HISTORIC AND DESIGN REVIEW COMMISSION

HDRC CASE NO: 2019-357
ADDRESS: 831 LAMAR ST
LEGAL DESCRIPTION: NCB 1368 BLK 5 LOT 21
ZONING: R-6, H
CITY COUNCIL DIST.: 2
DISTRICT: Dignowity Hill Historic District
APPLICANT: Octavio Viramontes/HACAM PROPERTIES LLC
OWNER: Octavio Viramontes/HACAM PROPERTIES LLC
TYPE OF WORK: Construction of a 1-story, single family residential structure
APPLICATION RECEIVED: July 26, 2019
60-DAY REVIEW: August 20, 2019
CASE MANAGER: Edward Hall
REQUEST:

The applicant is requesting a Certificate of Appropriateness for approval to construct one, 1-story single-family residence on the vacant lot at 831 Lamar, located within the Dignowity Hill Historic District.

Front setback comparison

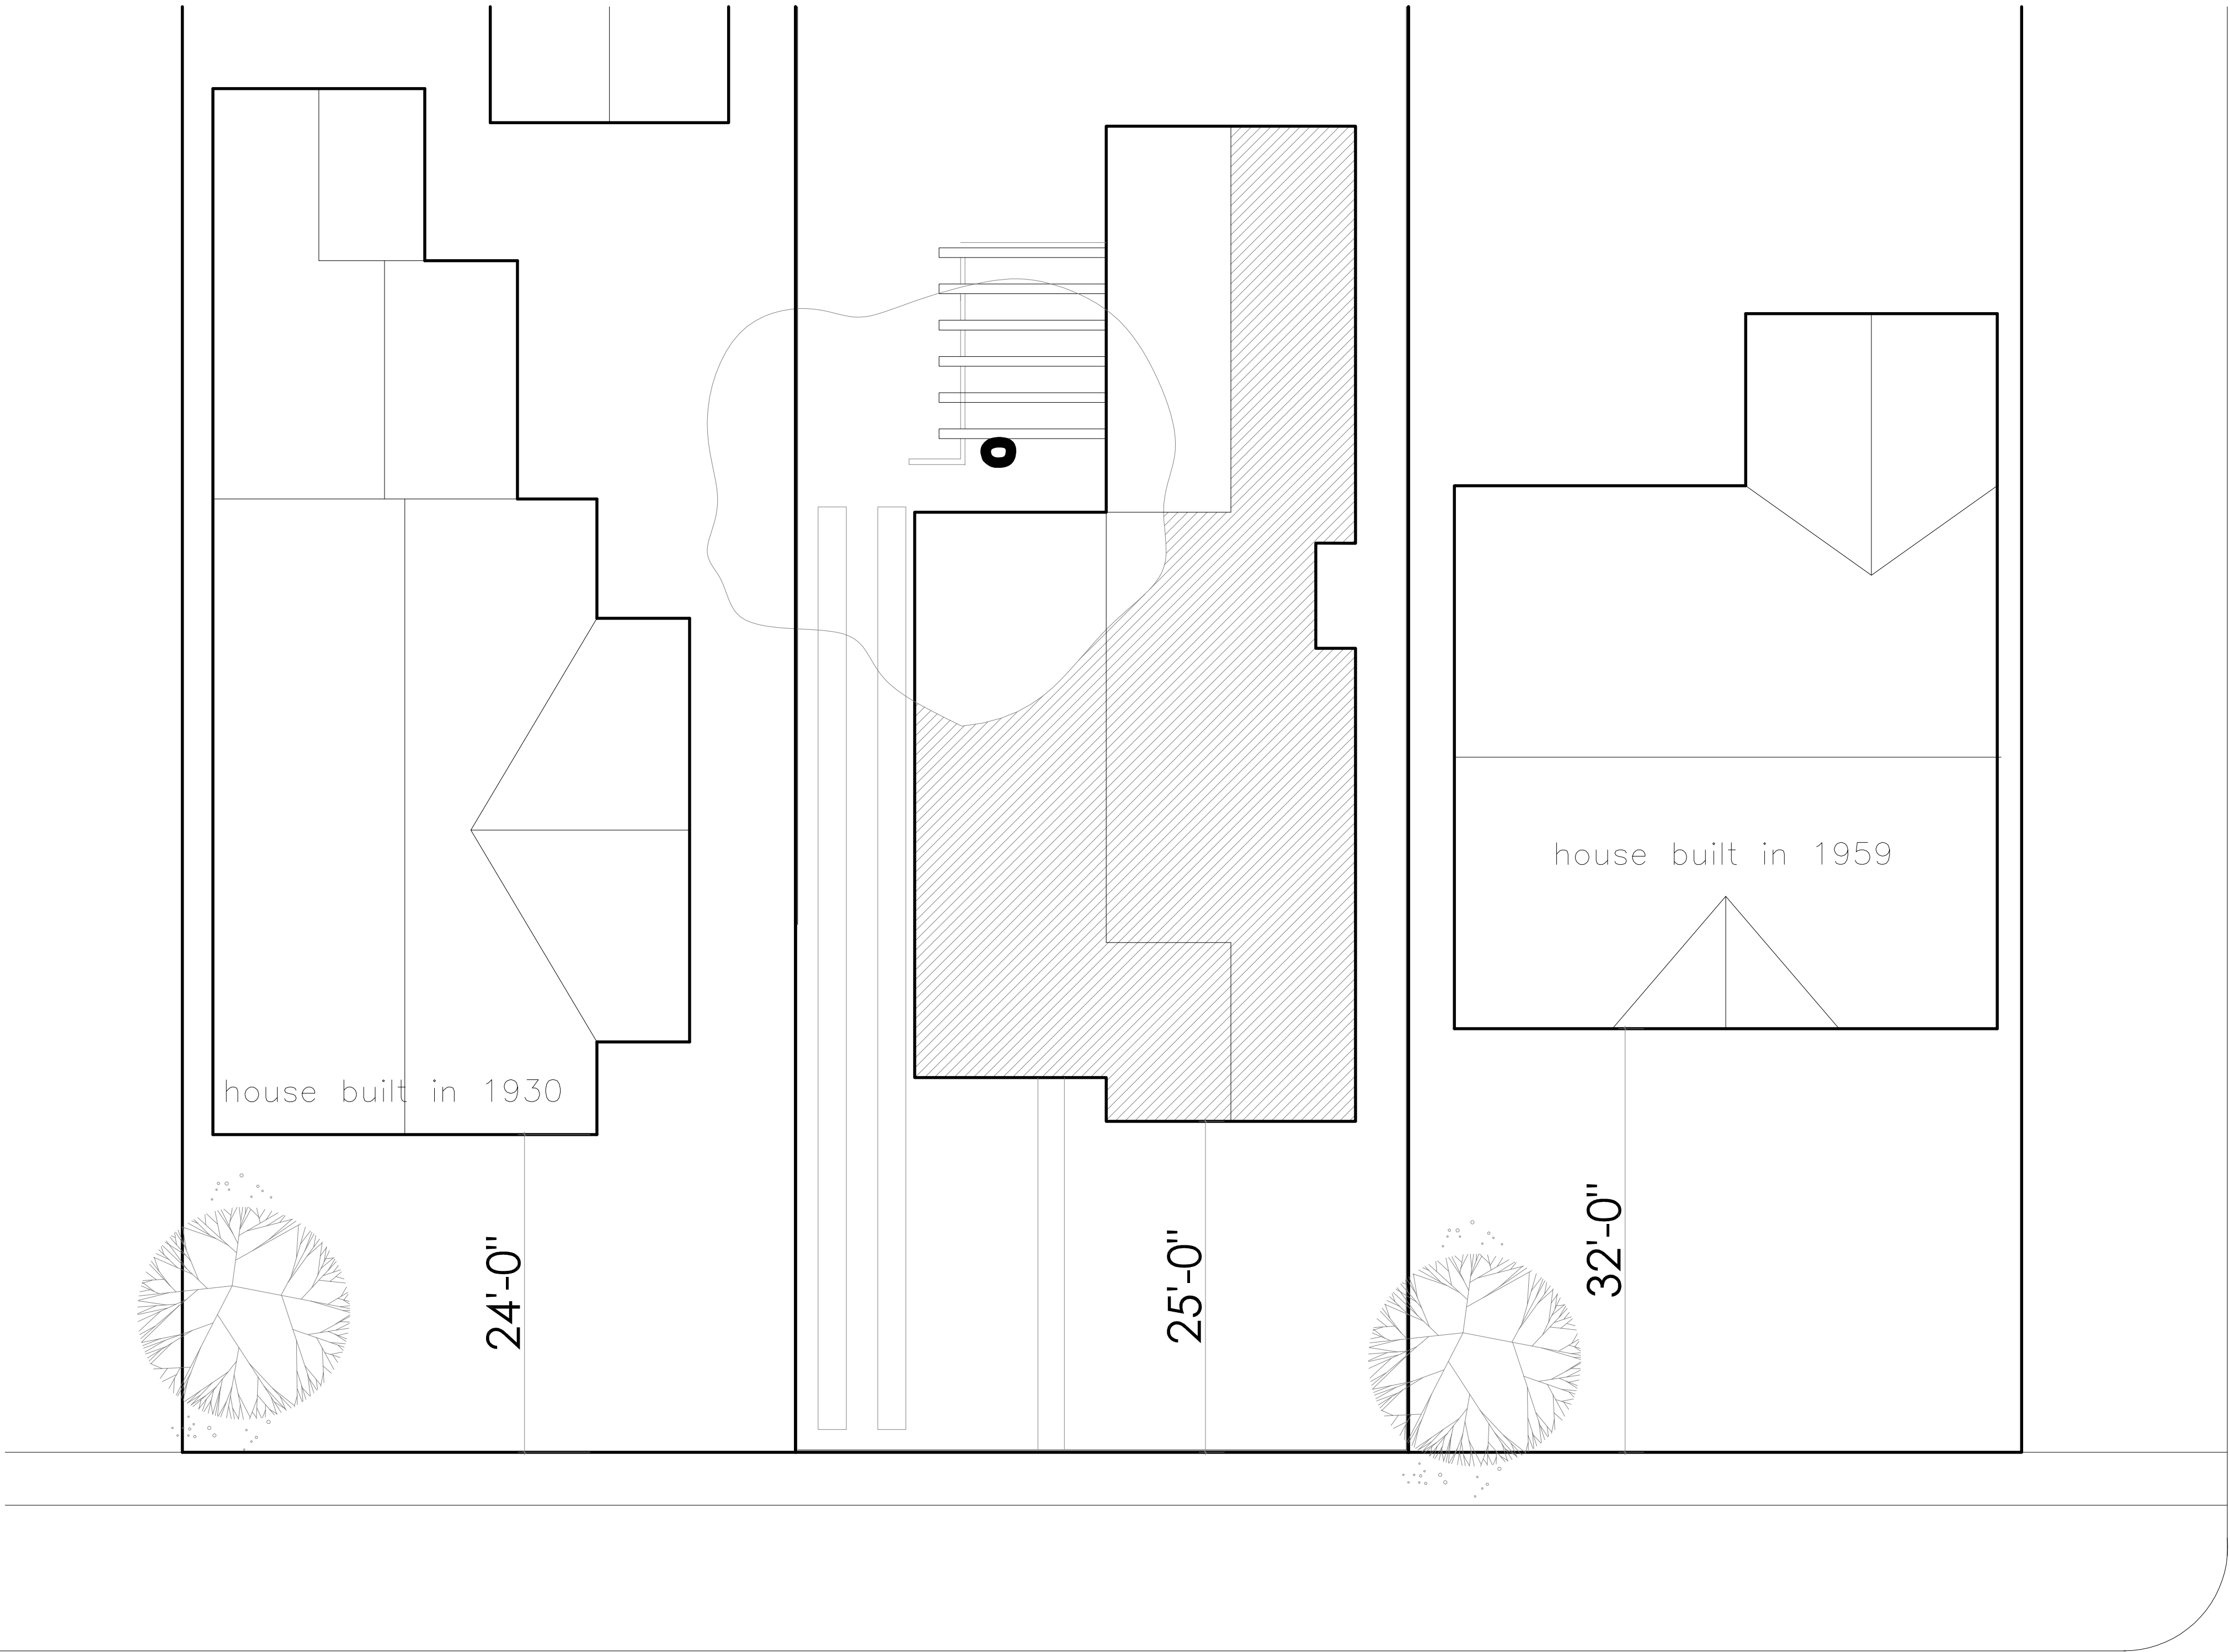
- i. That the applicant provide additional setback information to confirm that a setback that is greater than that of the historic structure to the immediate west is used. **The applicant has submitted an updated setback diagram that notes that a greater setback is proposed.**

COMMENTS/CONCERNS: CV: OVERVIEW OF PROJECT. ALL: DISCUSSION
OF PREVIOUS STAFF COMMENTS, CF: DISCUSSION REGARDING
SETBACK, AND PEACH TREE, CF: NEW SETBACK ~~IS~~ IS APPROPRIATE,
(PROPOSED GREATER THAN HISTORIC HOUSES), CF: ADJUST ROOF
PITCH IF DESIRED. ~~ALL~~ ~~CONSIDER~~ CONSIDER ADDITIONAL PENESTRATION
